**STATE OF ALASKA DEPARTMENT OF TRANSPORTATION & PUBLIC
FACILITIES (DOT & PF)
DALTON HIGHWAY MP 0-9 RECONSTRUCTION
VALUE ENGINEERING STUDY
FINAL REPORT
JULY 25, 2017**

This Value Engineering (VE) report is presented to the Alaska Department of Transportation and Public Facilities (DOT & PF) to assist in decision making at the 40% design level. The goals for this VE study were to identify component and planning alternatives that may offer first cost or life cycle cost benefits and/or improve project quality. During the kick-off meeting, the design team defined the following criteria as most important to the project:

LOST CREEK BRIDGE PROPOSED B3

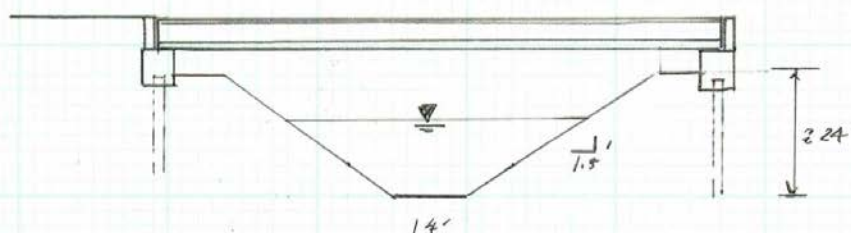
PROPOSAL	B3
COMPONENT: Bridge - Span	AUTHOR	MJM
CURRENT CONCEPT: Lost Creek Bridge Crossing consisting of a single span pre-cast concrete bridge (39'x142.5' bulb-tee) on driven steel HP14x117 piles. Design also includes over 2000 cubic yards of riprap (Classes I and III) for scour protection.		
VE CONCEPT: Refine the proposed design reducing the proposed bridge span from 142.5 feet to 110 feet.

PROPOSAL	B3
COMPONENT: Bridge - Span	AUTHOR	MJM
<p>DISCUSSION:</p> <p>This VE proposal is based on reducing the overall bridge span by over 30 feet. The success of this proposal will be dependent on the final hydraulic analysis including estimates of scour.</p> <p>The shorter span will allow for a shallower girder which results in a significant weight reduction. By inspection, shorter and lighter girders should be easier to ship and erect. Further savings could be realized if this proposal is combined with material reductions discussed in proposals B1 and B2.</p>

$$L = 14' + 2(36') + 2(5') + 2(4')$$

$$L = 104' \Rightarrow \text{SAY } 110'$$

CONCRETE TECHNOLOGIES 53" (4'-5")
 BULB TEE WILL SUPPORT HL-93 LOADING AT THIS SPAN

HYDRAULIC CHECK

$$Q = (1.49/0.04) (442.5 \text{ ft}) (6.4)^{3/2} \sqrt{0.01} = 5720 \text{ cfs O.K.}$$

PLATE ARCH STRUCTURE ALTERNATIVE - B4

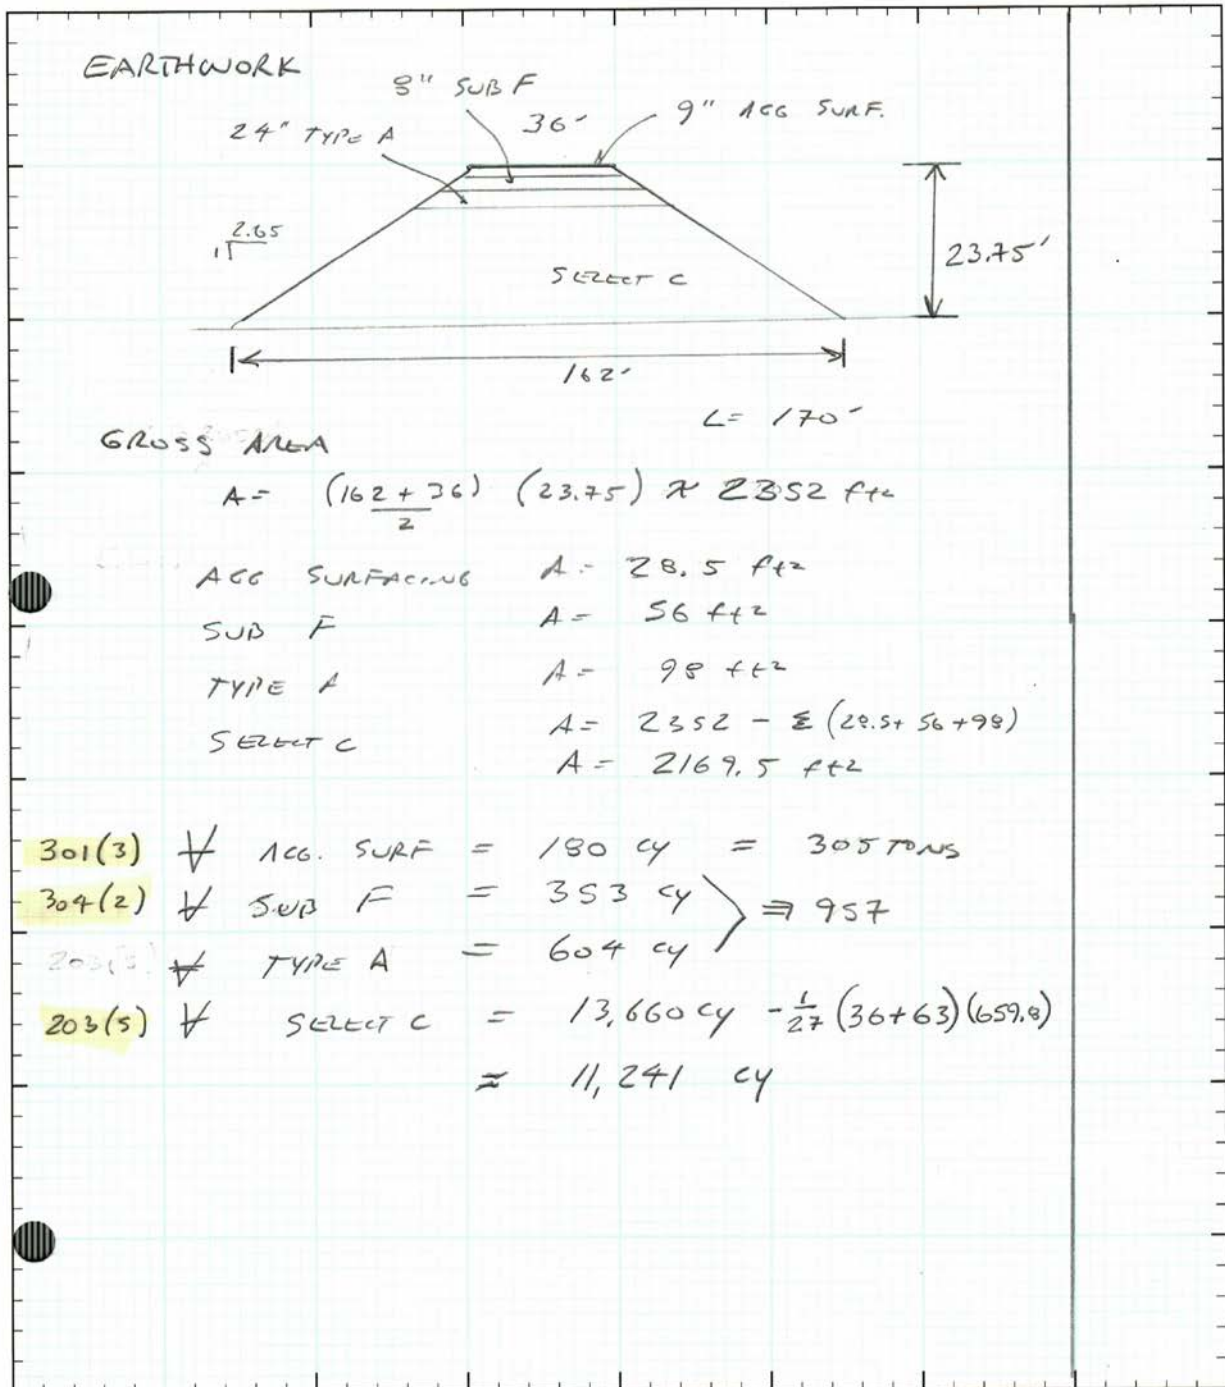
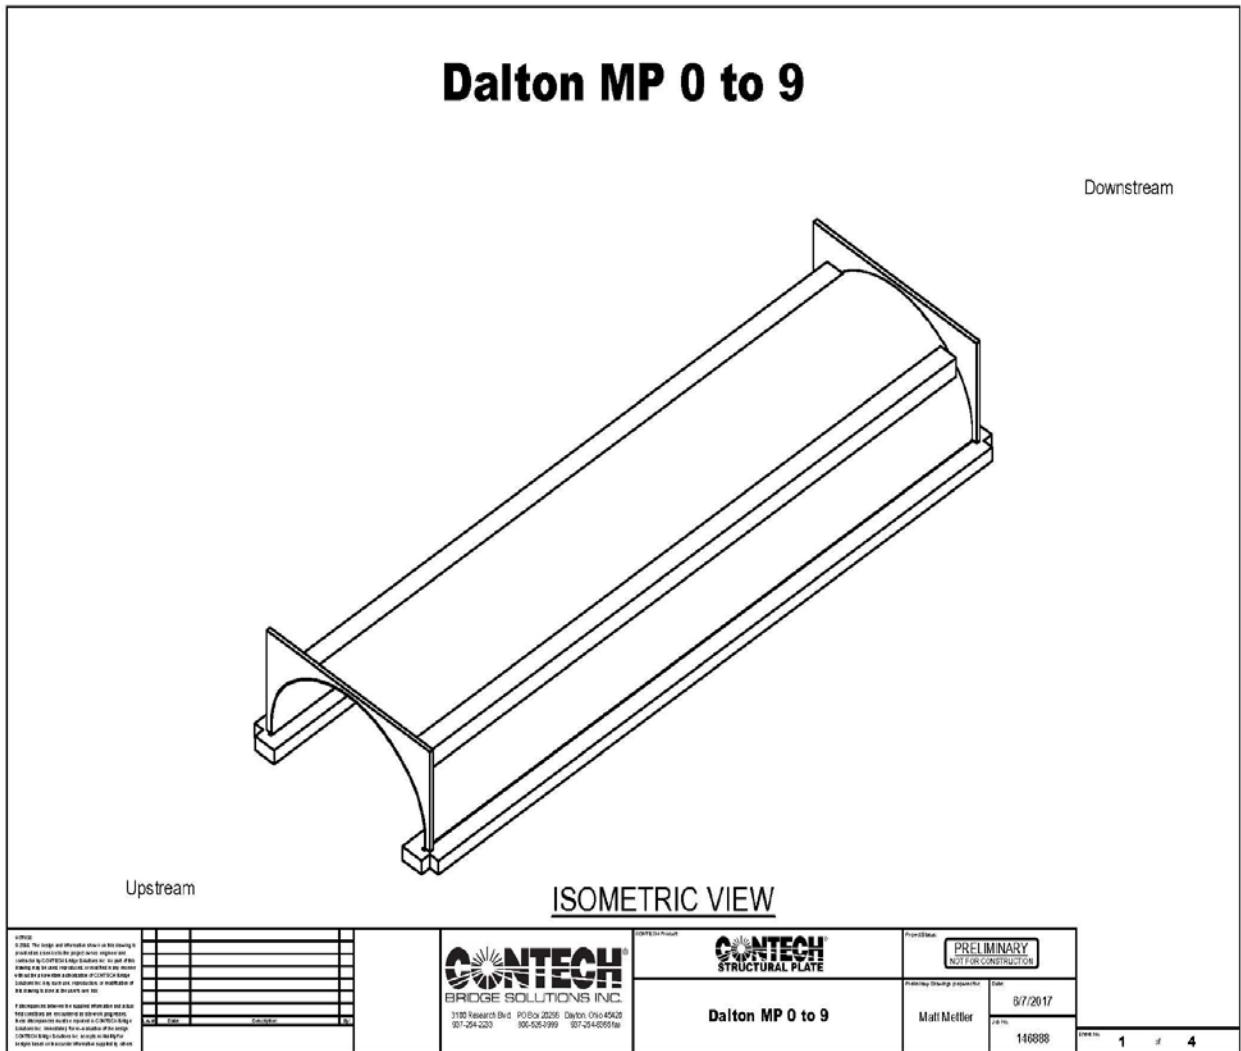
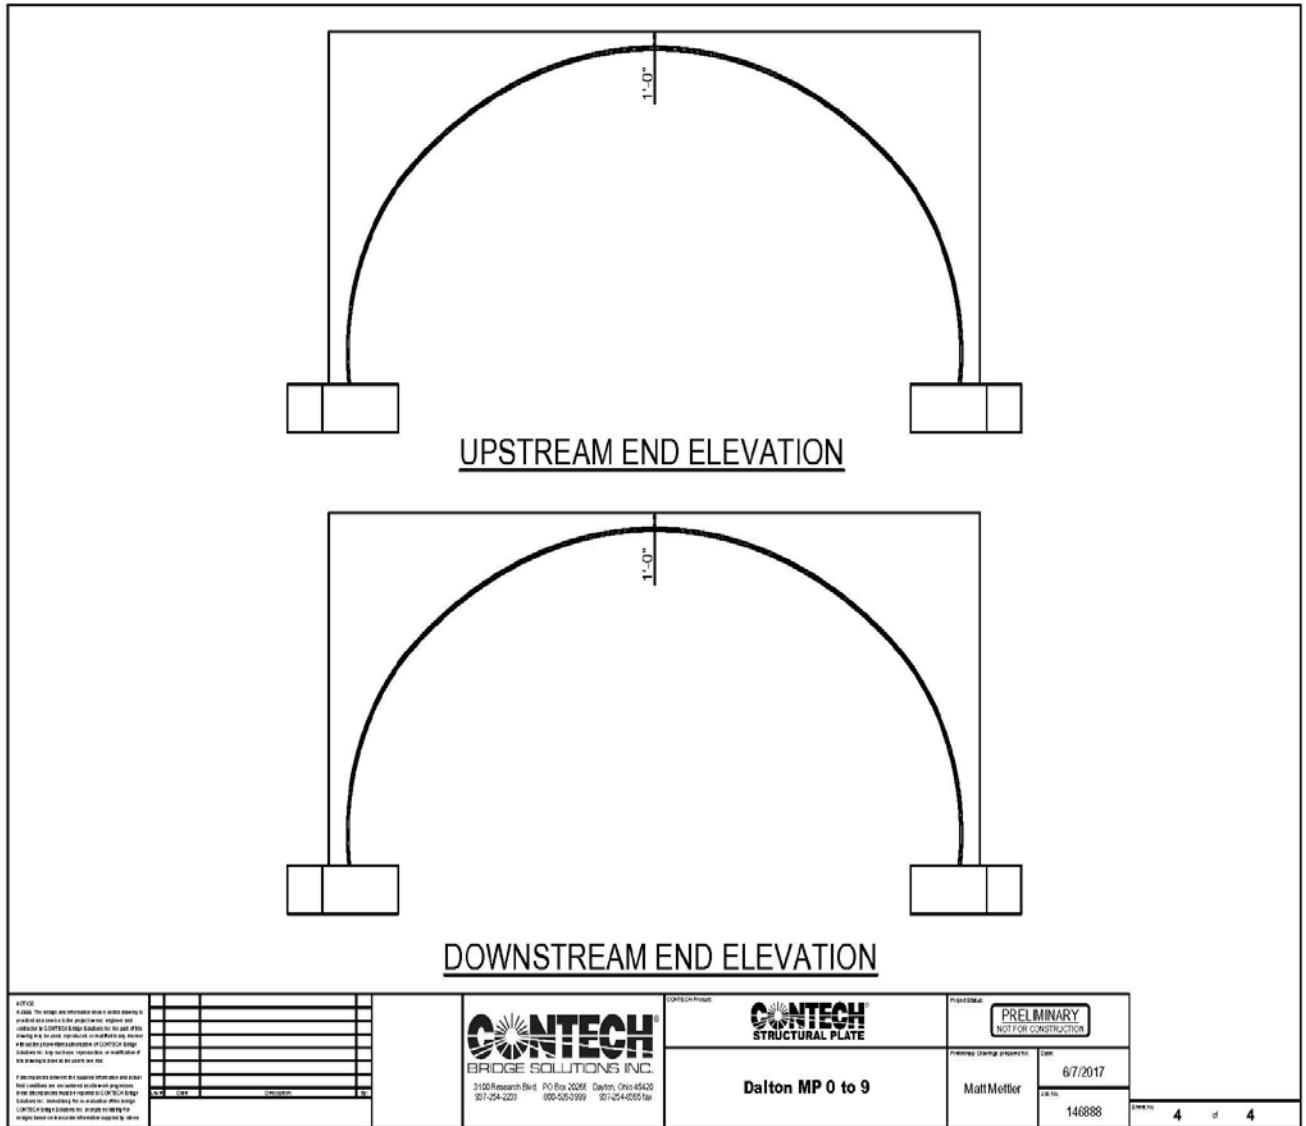
PROPOSAL	B4
COMPONENT: Bridge – Structural Plate	AUTHOR	MJM
<p>CURRENT CONCEPT:</p> <p>Lost Creek Bridge Crossing consisting of a single span pre-cast concrete bridge (39'x142.5' bulb-tee) on driven steel HP14x117 piles. Design also includes over 2000 cubic yards of riprap (Classes I and III) for scour protection.</p>		
<p>VE CONCEPT:</p> <p>Corrugated, low-rise structural plate-arch structure having a span of 45' and a rise of approximately 19'. Culvert will be supported on concrete grade beams that can be site cast or pre-cast off-site and transported to the field. The culvert will be buried using earth materials depicted on the current typical sections (E1 surfacing, grade F sub base and Select C).</p>

PROPOSAL	B4
COMPONENT: Bridge – Structural Plate		AUTHOR	MJM
<p>ADVANTAGES:</p> <ul style="list-style-type: none"> • Less cost • Less transportation cost to mobilize construction materials to the site. • Provides adequate hydraulic opening for the design flows. • Will use materials already planned for road construction 	<p>DISADVANTAGES:</p> <ul style="list-style-type: none"> • Hydraulic opening is not as large as proposed bridge. 		
<p>DISCUSSION:</p> <p>This VE proposal is based on material unit costs listed in the DSR estimate and costs obtained from a known manufacturer/supplier of plate arch structures. Cost for the plate arch structure includes panels, fasteners and labor required to erect the structure. Grade beams and thrust beams are included as separate line items.</p> <p>We verified the hydraulic capacity based on calculated flows provided by ADOT&PF. Assumptions included a channel slope of 1% and a manning’s coefficient of 0.04. Based on these assumptions the proposed alternative can pass the 100 and 500 year flows satisfactorily.</p>

SPAN 45'
RISE 18.67'

602 (1) $A = \pi/2 (22.5)(18.67) = 659.8 \text{ ft}^2$

QUICK HYDRAULIC CHECK USING
MANNINGS EQUATION

PROPOSAL	R1
COMPONENT: Roadway Construction – Material Sourcing	AUTHOR	RDP/DS

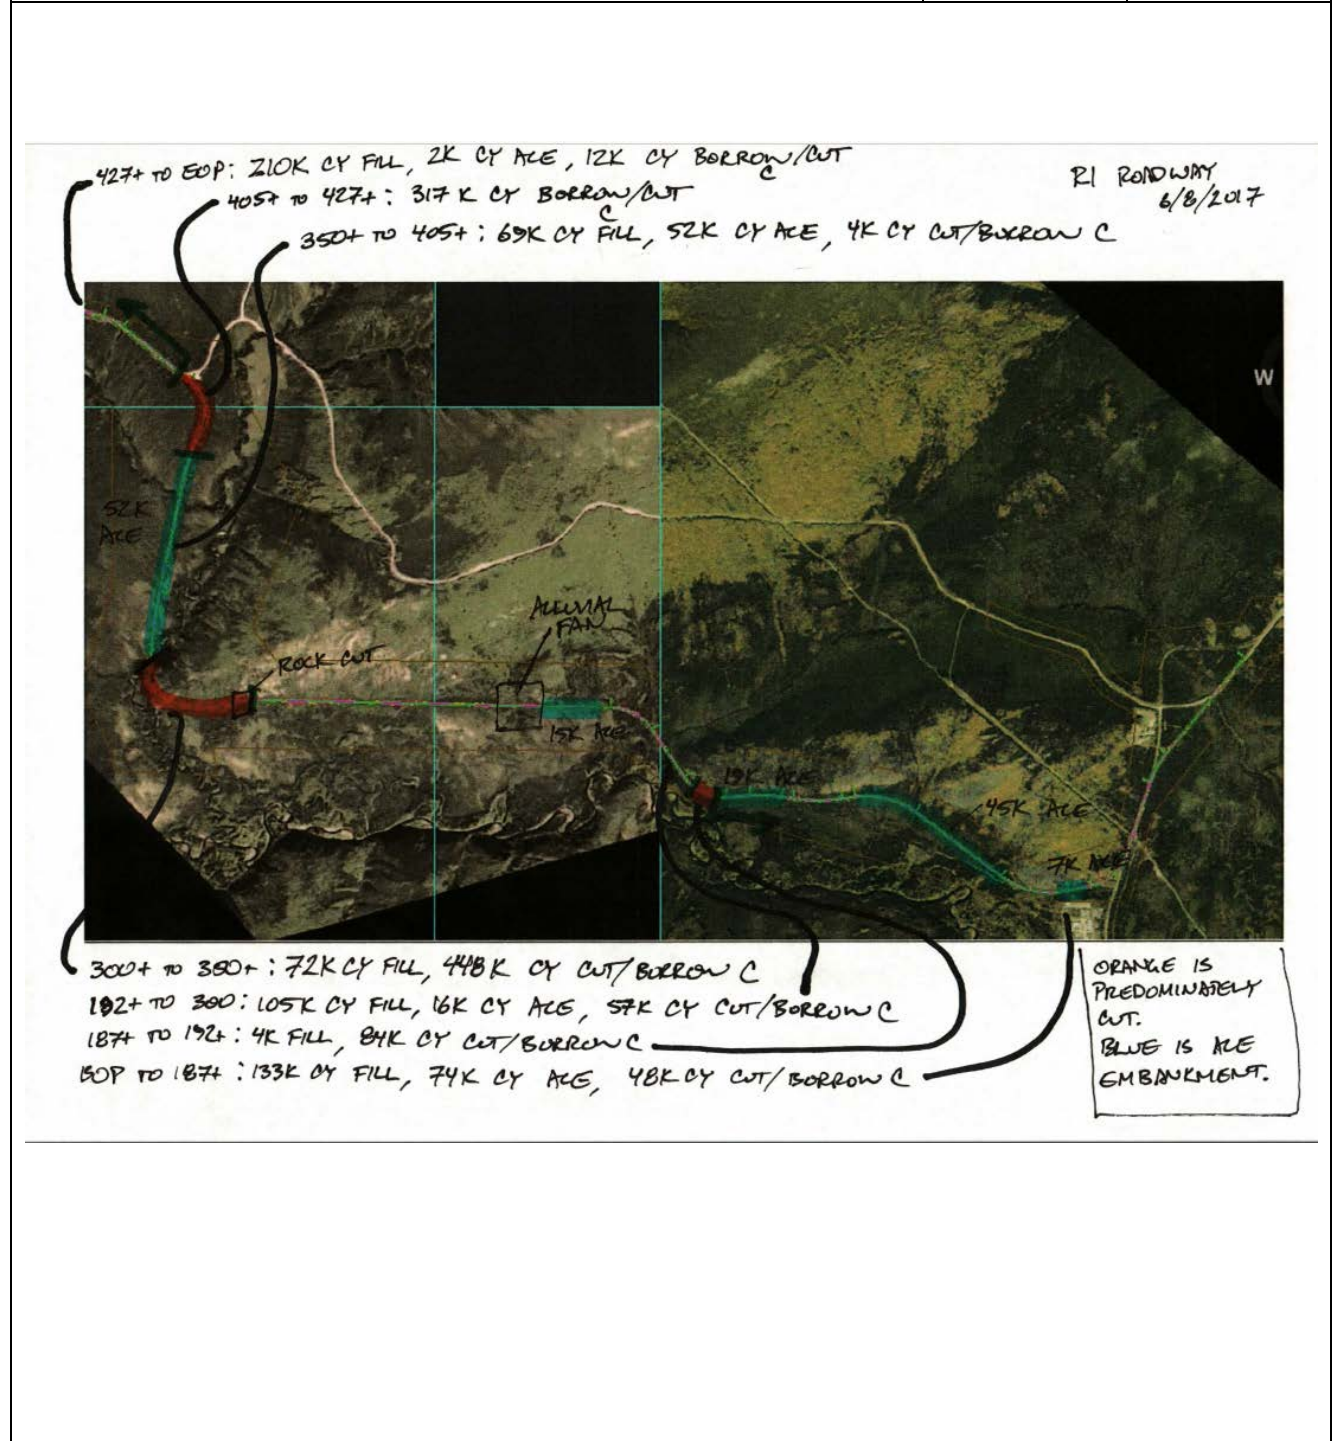
PROPOSAL	R1
COMPONENT: Roadway Construction – Material Sourcing	AUTHOR	RDP/DS
<p>CURRENT CONCEPT:</p> <p>Provide ACE material from 19-mile pit for entire project. Provide borrow A/B predominately from Lost Creek material site near MP 6.5.</p>		
<p>VE CONCEPT:</p> <p>Evaluate rock cut at 300+00 to 308+00 for producing ACE embankment rock. If rock is suitable for ACE, increase ROW similar to or exceeding the expansion at 245+00 to 260+00 (alluvial fan material source).</p> <p>Evaluate and identify useable cut materials from 10+00 to 350+00 for borrow A, B, & C to reduce haul costs, and allow for substantial embankment completion without hauling over Lost Creek. Provide any additional required borrow A/B from alluvial fan material source.</p>

COMPONENT: Roadway Construction – Material Sourcing	PROPOSAL	R1
	AUTHOR	RDP/DS
<p>DISCUSSION:</p> <p>There are several advantages of acquiring the materials as close as possible to the fill and embankment areas. Haul costs are always a large driver in overall project costs and reducing these costs is certainly a significant advantage. Sporadic areas of ACE as identified in the geotechnical recommendations will also require a staged type of embankment construction. ACE is unique as it is recommended for winter placement and may not be driven on after placement without the driving surface being placed.</p> <p>Dividing the project into two sections at Lost Creek will be the most effective and efficient method to complete the ACE embankment, and to be efficient requires identifying an ACE source south of Lost Creek. Hauling the entire project ACE embankment from the north end (19-mile pit) may require winter haul/stockpiling on the south side of Lost Creek, or hauling on the existing Dalton/Elliott to the southern part of the project. Sourcing ACE material south of Lost Creek would reduce material costs and the quantity of material that would need to be hauled from the 19-mile pit.</p> <p>Mining a sufficient quantity of ACE material south of Lost Creek (~74K CY) may require additional ROW acquisition and permitting; specifically, between 300+00 and 308+00 or 187+00 to 192+50. Using material for ACE may reduce material available to process for select A or B; mining of the alluvial fan at 250+00 may provide adequate material.</p>

North End: Assume useable cut from Lost Crk mtl site used for fill north of bridge; 317K CY available and 263k CY needed; remainder can be processed to Select A/B. ACE material is assumed to come from 19-mile Pit for north segment.				
					South End: Useable excavation from cut area at 190+ is sufficient for needed fill to south (BOP to 187+). Useable excavation from 300+ to bridge is more than sufficient to cover required fill (~49K CY) between 192+ and 300+; profile could be modified to reduce excavation. Assume ACE material can be mined from rock cut area at 300+ or from alluvial fan area at 250+, resulting in lower unit cost. Assume needed Select A/B required south of bridge can be mined from alluvial fan; quantities indicate 1.5' depth provides 90K CY Select A/B, so mining 3-4' deep to provide 192K CY required is reasonable.				
Subtotal				20,435,500	Subtotal				17,082,000
General Contractor Markup		%			General Contractor Markup		%

Replace Clearing and Grubbing 201(3A) w/ Clearing 201(1A)
Beneath Minimum 5' High ACE

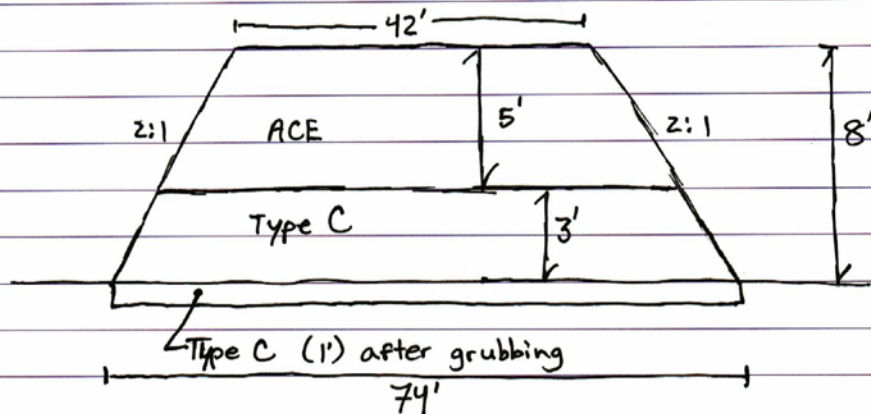
PROPOSAL	G2
COMPONENT: Geotechnical – Permafrost Provisions – Tundra Excavation	AUTHOR	DJ
CURRENT CONCEPT: During winter, clear and grub prior to placing ACE fill (assuming minimum ACE fill height of 5'). Replace grubbed material with select material Type C.		
VE CONCEPT: Replace clearing and grubbing with clearing only and place select material Type C over existing ground.

- Assumptions:
- Embankment height to top of ACE is typically 8'
 - Approximately 1' of material is removed and replaced w/ Type C borrow to EG.
 - Typical section is as shown below.

Area = $(74')(14,550 \text{ LF}) / 43560 \text{ sf} = 24.72 \text{ Acres} \Rightarrow \$197,760$
Type C Vol = $(74')(1')(14550') / 27 = 39,878 \text{ cy} \Rightarrow \0 , assuming placement of 1' of Type C does not add to cost due to excess Type C being generated by required cuts.

G2	Geotechnical - Permafrost Provisions - Tundra Excavation	74,000	X			\$74,000	This will be added along with the requirement that clearing is to occur during the winter (or frozen conditions).
G3	Geotechnical - Permafrost Provisions - Deep Excavation / Oversized Embankments	4,149,000			X		This proposal will/may be utilized at very limited/select locations and only during winter and only as scheduling would practically accommodate. Overall, NR is uncomfortable subexcavating to remove frozen material as the risk is uncertain yet potentially high, not only due to the uncertainty of the limits of excavation or the conditions encountered but also due to the negative scheduling impacts these ambiguous "dig outs" could have, primarily as they would all take place along the new road and likely sole haul route. There is also some moderate risk in efforts necessary to maintain CGP compliance. There are isolated locations, however, where the limits of are either better known or will have a more manageable amount of potential risk.
